**DATE:** April 18, 2017

**FROM:** Evan Canfield, P.E.  
Civil Engineering Manager

**SUBJECT:** Evaluating Effects of Rosemont Mine on Downstream Flows at Davidson Canyon

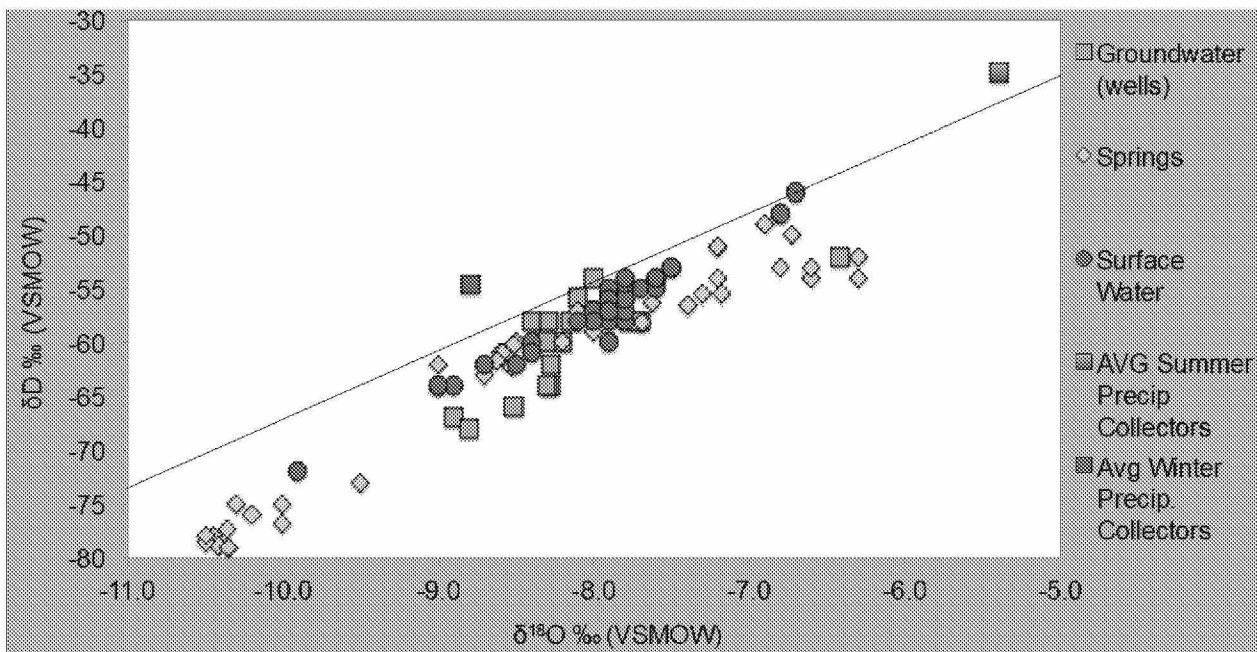
### ***b. A Conceptually More Complex Model Calibrated to the Cienega Gauge Already Exists on a Daily Timestep***

The Soil Water Assessment Tool (SWAT), a continuous simulation operating on a daily time step, which is suitable for evaluating Land Use Change. SWAT is used in the EPA BASINS (Better Assessment Science Integrating Point and Nonpoint Sources) modeling used to assist in watershed management and TMDL development.

Because SWAT has been calibrated for the Santa Cruz River Basin using 14 gaging stations including Cienega Creek and Pantano Dam data (Niraula et al. 2015), and is used by the EPA to evaluate watershed management, I believe that it is an appropriate tool for evaluating the effects of the Rosemont Mine on flows and sediment within Davidson Canyon as required by the 401 certification.
